DEPARTMENT OF NATURAL RESOURCES
DIVISION OF OIL, GAS AND MINING

TO: Minerals File
FROM: Doug Jensen, Paul Baker, Reclamation Specialists
RE: Site Inspection, Lone Star Industries, Inc., Little Mountain Quarry, M/045/005, Quarry Antone, M/045/021, Tooele County, Utah

Lone Star Industries Tooele County Quarries

Flux Quad

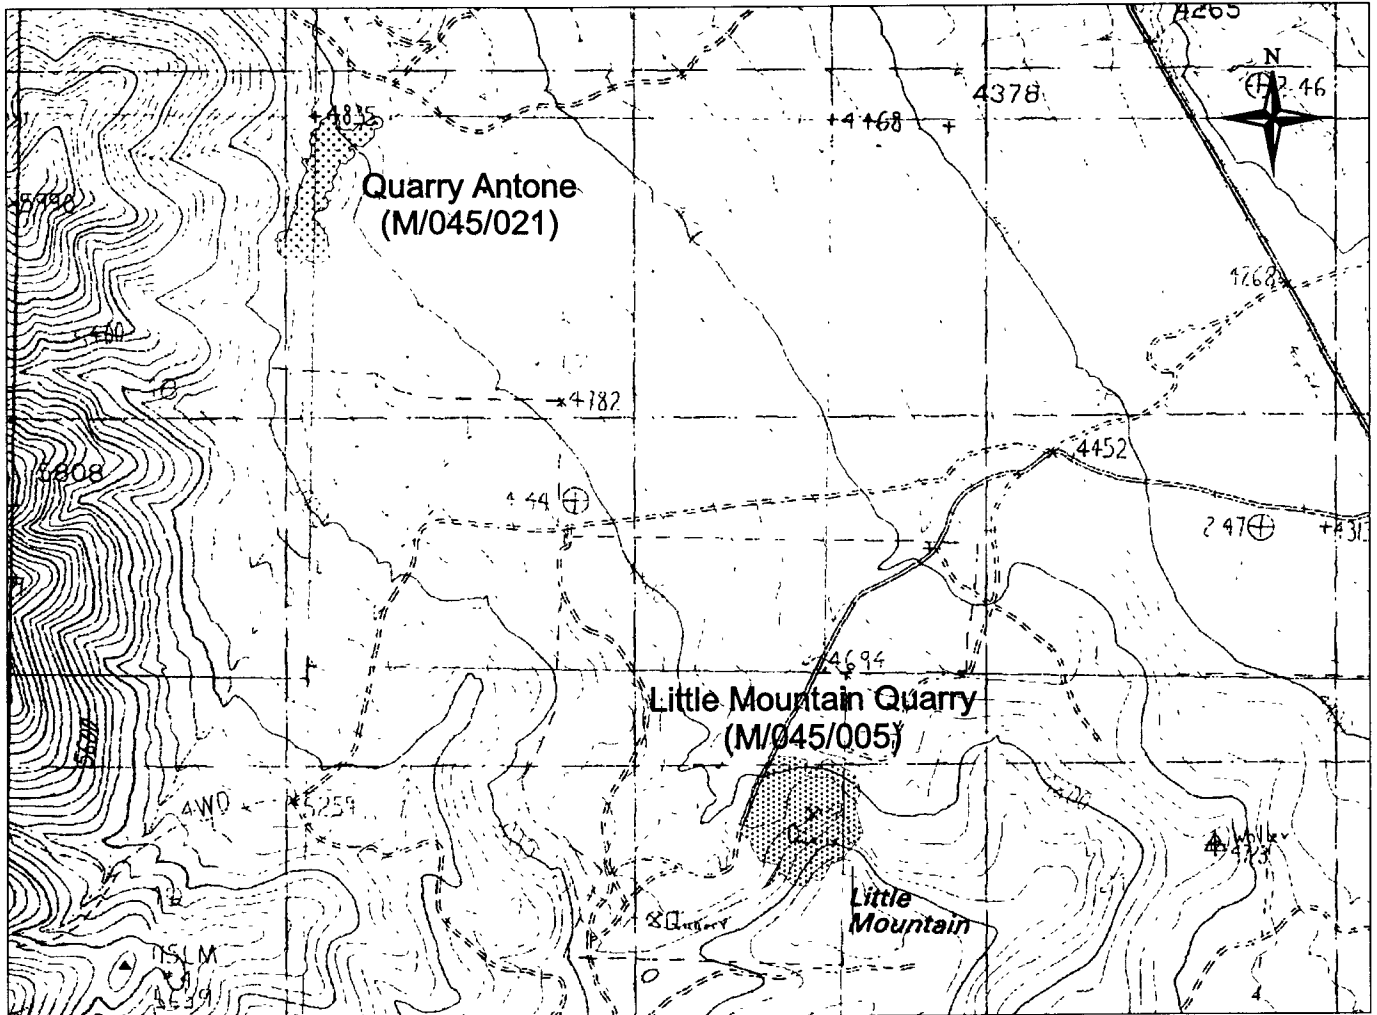
A GPS survey was completed at both sites to document the disturbed acre footprint at each site. The survey indicated that the Quarry Antone area of disturbance to be 11.65 acres; this site is presently permitted to disturb 8 acres. The Little Mountain Quarry survey showed a disturbance of 23.29 acres; this site is permitted to disturb an area of 20 acres.

Because both sites are presently out of compliance, it is recommended that Lone Star (1) amend the present permits to include the additional acreage indicated by the GPS survey; and (2) update the existing bonds to the escalated amount, before the Division supports Lone Star's application to extend the period of suspension for these two mines.
